REMEDATION METHOD STATEMENT

PHASE 3, PROLOGIS PARK, HAYES

29 October 2013

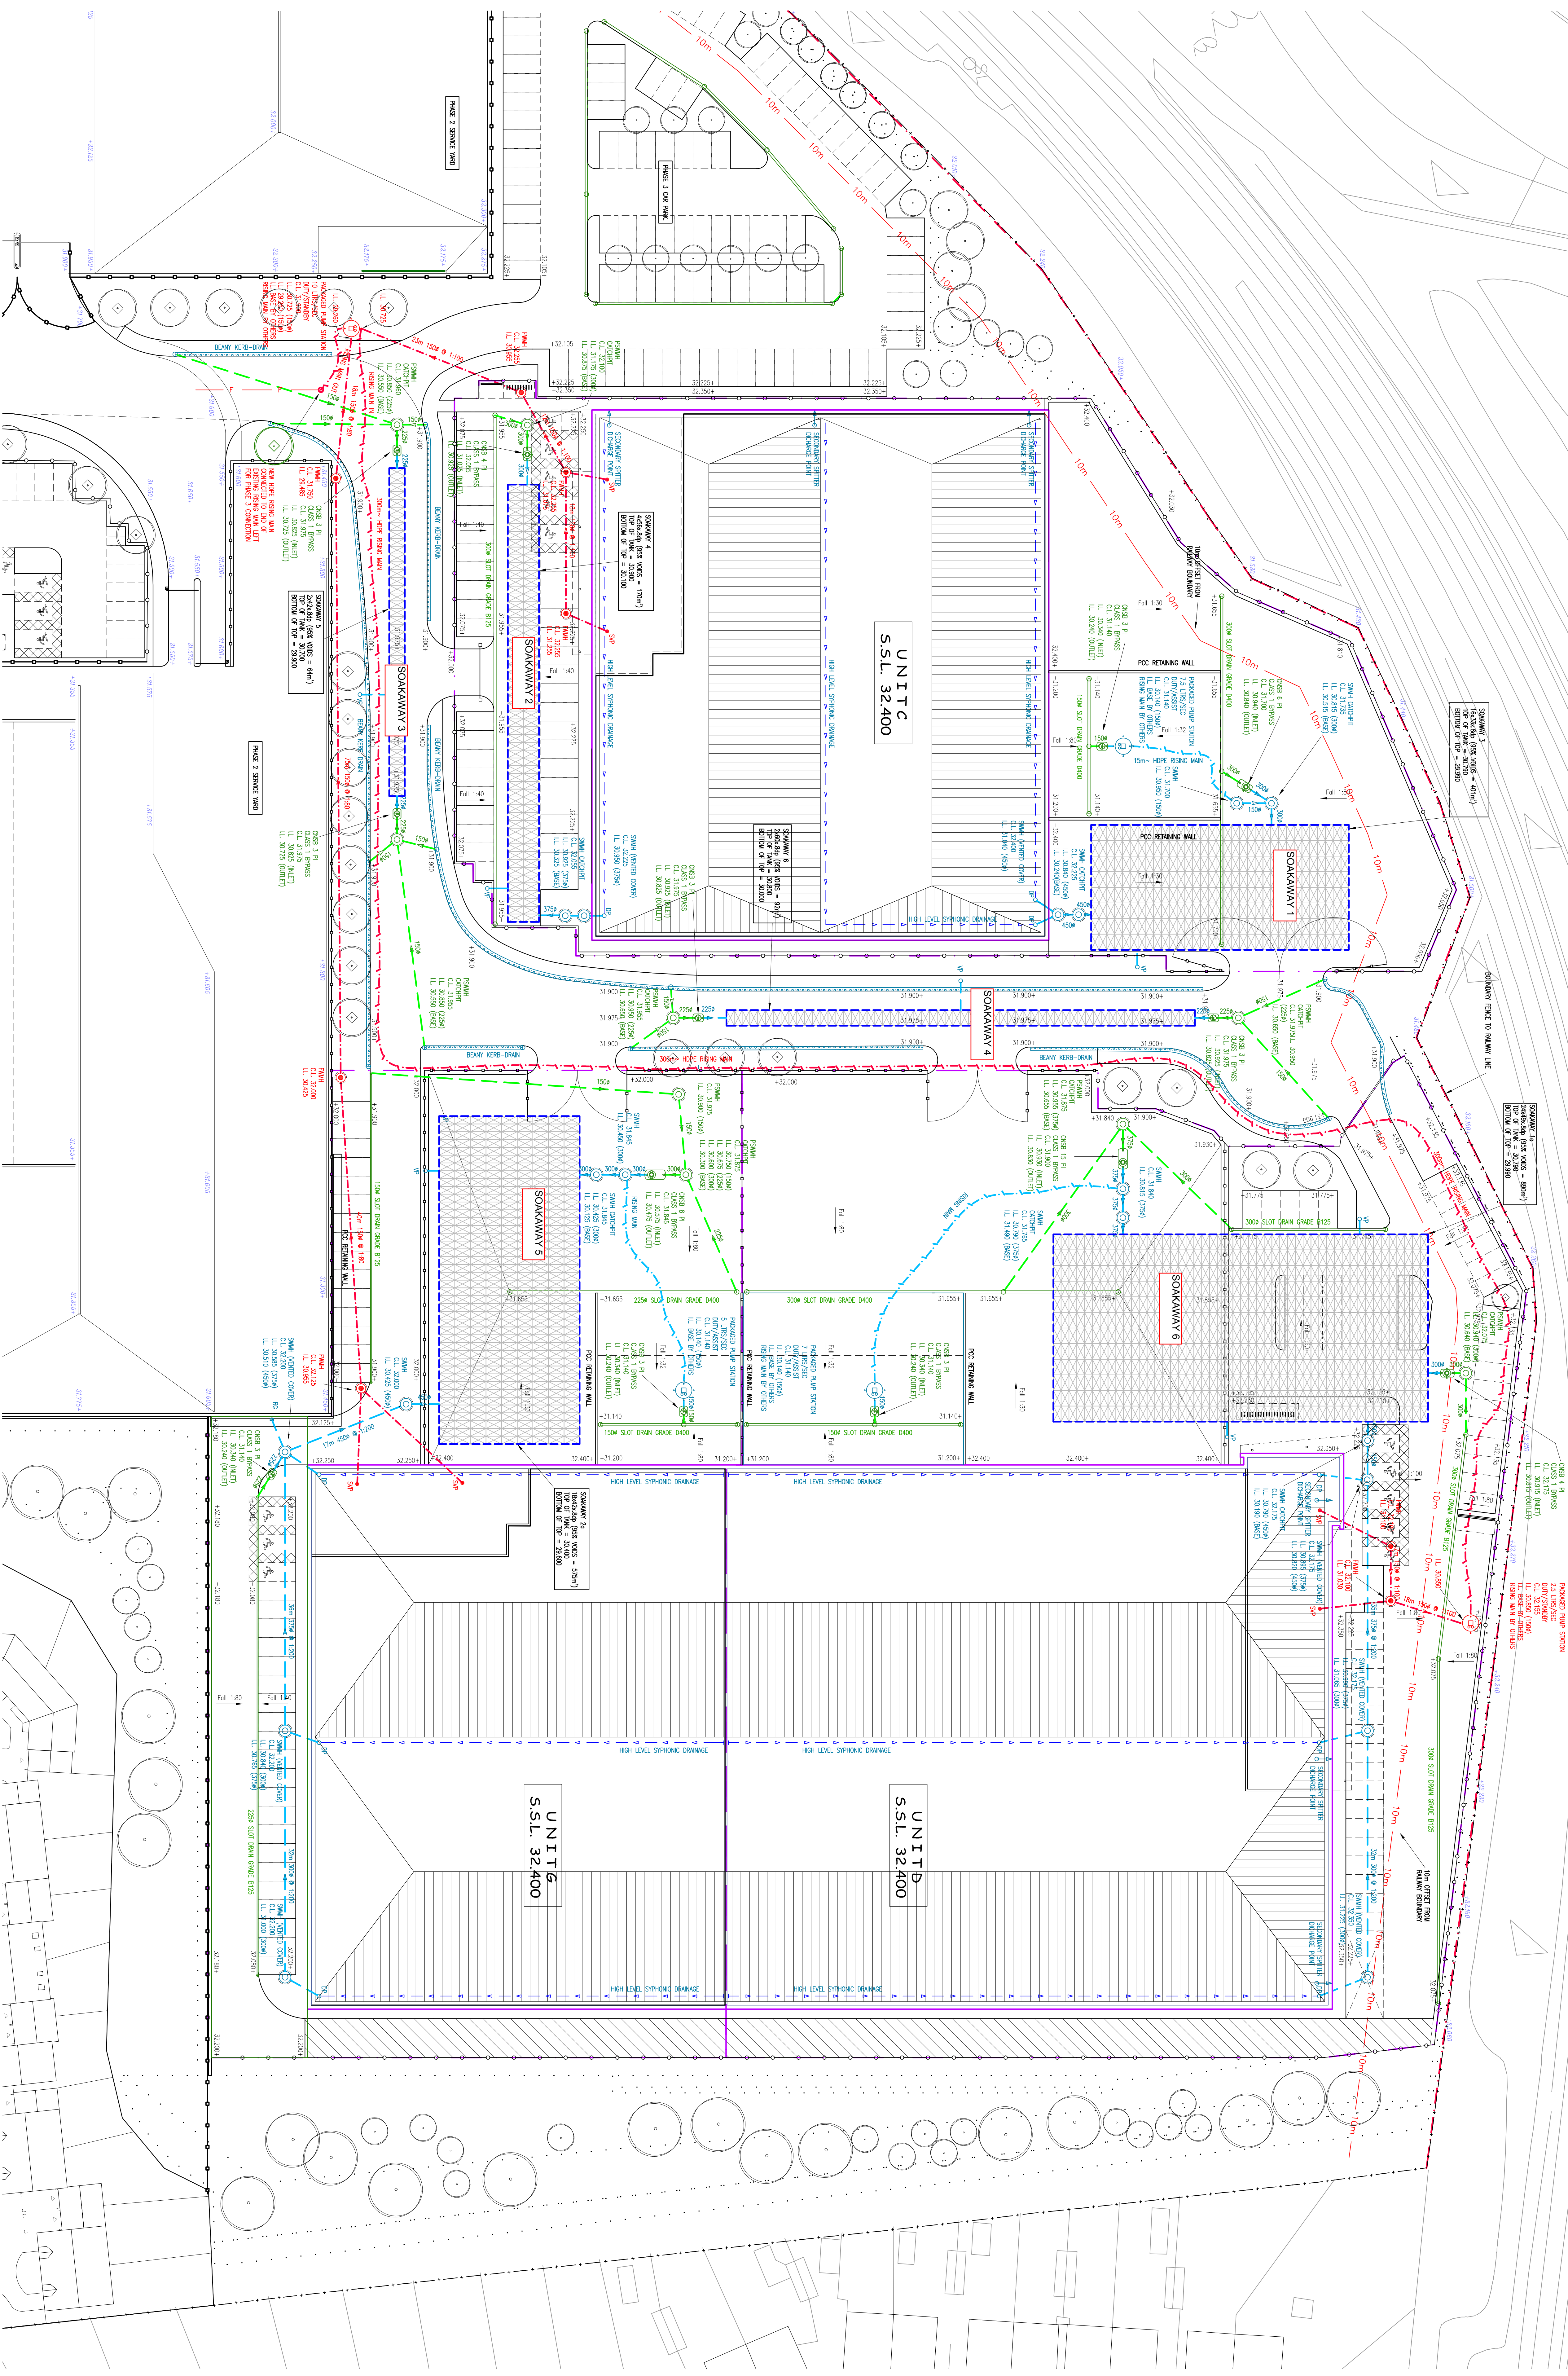
The drainage layout drawing indicates that six soakaways are proposed to be installed on-site (annotated by WSP on **Figure 1**) to the north, east and south of the proposed Unit C in the west of the site.

The base of the proposed soakaways are shown on the drainage strategy (**Figure 1**) at elevations of 29.9 metres Above Ordnance Datum (m AOD) to 30.1m AOD with proposed finished external levels at approximately between 31.8m AOD and 32m AOD. Current ground levels are at approximately 31.5m AOD indicating that the soakaways will extend to approximately 1.5m below current levels.

Based on the levels provided in the drainage strategy (**Figure 1**) excavation of the soakaways should remove the impacted Made Ground (presumably for re-use elsewhere on site away from the areas of infiltration), removing the potential for infiltration through contaminated soils.

PROJECT NO:	38063-004101	DRAWING NO:	FIGURE 2	REV:	-
-------------	--------------	-------------	----------	------	---

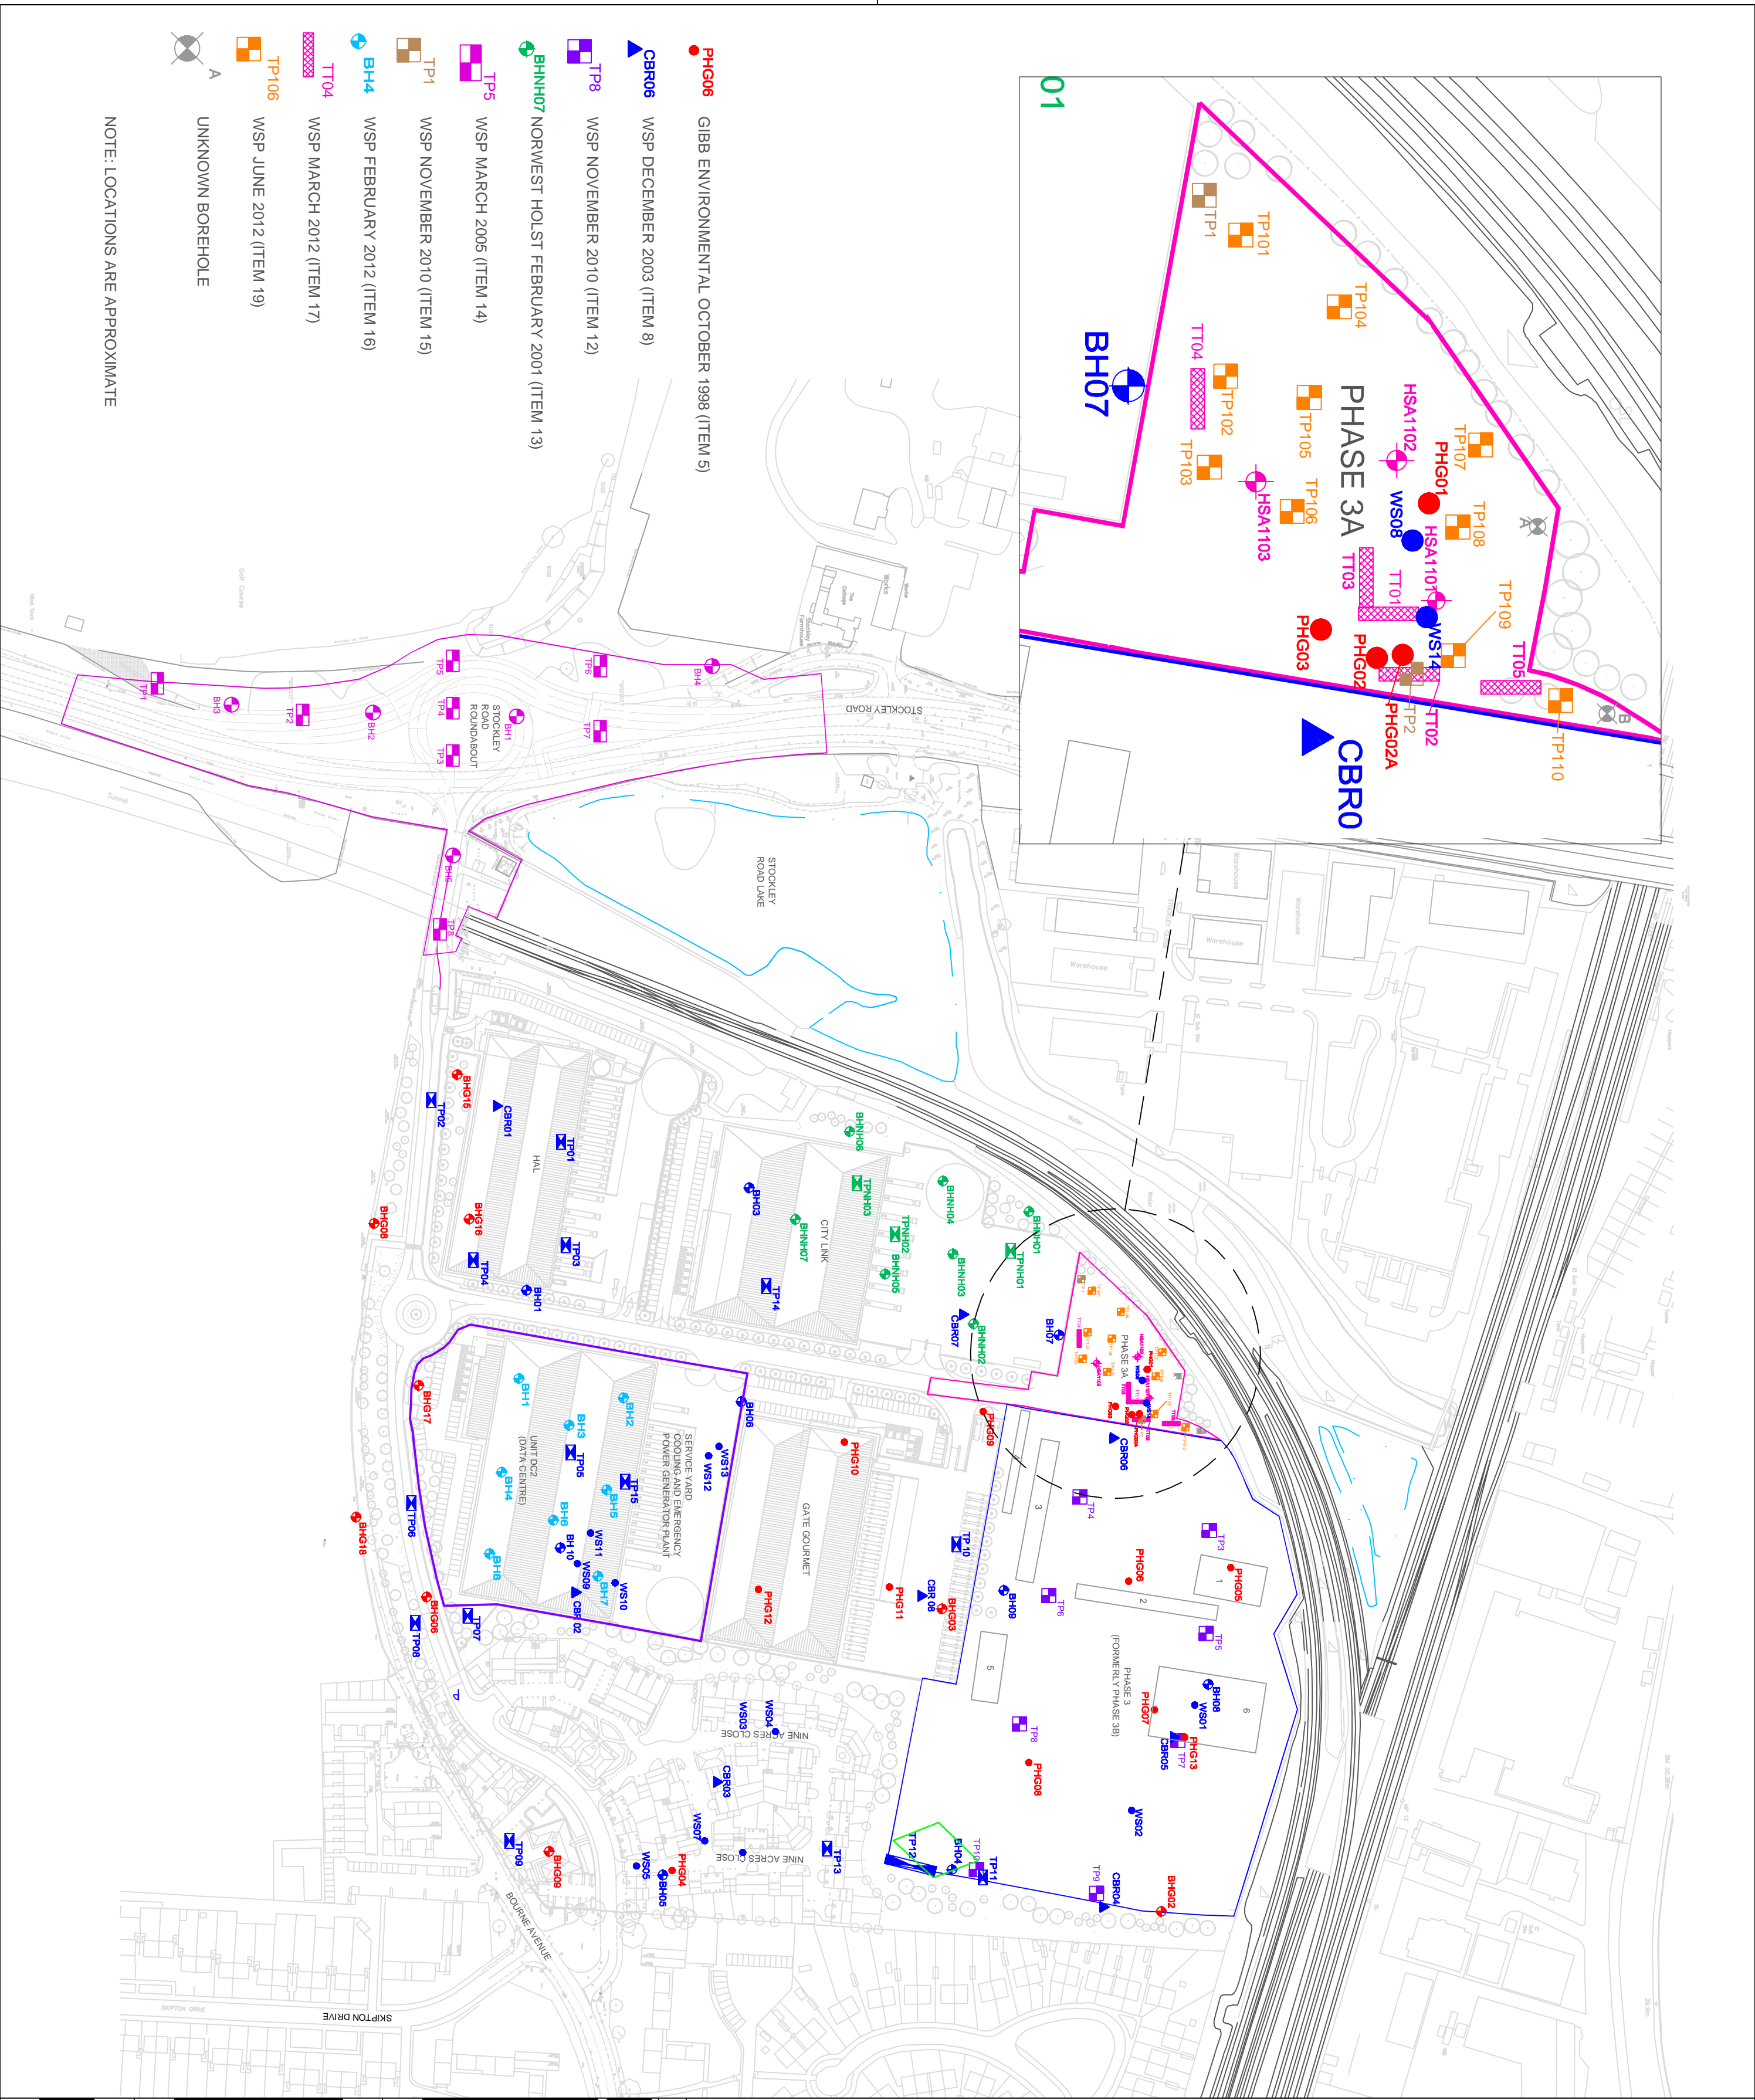
The anticipated ground conditions at each soakaway location have been assessed through comparison of the proposed soakaway locations and the proximal ground investigation exploratory hole locations. This assessment is provided in **Appendix A** and the approximate locations of the soakways are shown on an exploratory hole location plan presented as **Figure 2**.

The information provided in **Appendix A** and on **Figure 2** confirms that recorded contaminant concentrations exist in the approximate proposed location of Soakaway 6, albeit at shallow levels. There is limited investigation information in the close proximity to the remaining soakaway locations, although there is nothing to suggest from the previous investigations or land use that further significant contamination should be expected.

WSP conclude that the soakaways should not be affected by low level site contamination previously recorded on the site and any such risks will be mitigated through the construction of the infiltration drainage system.
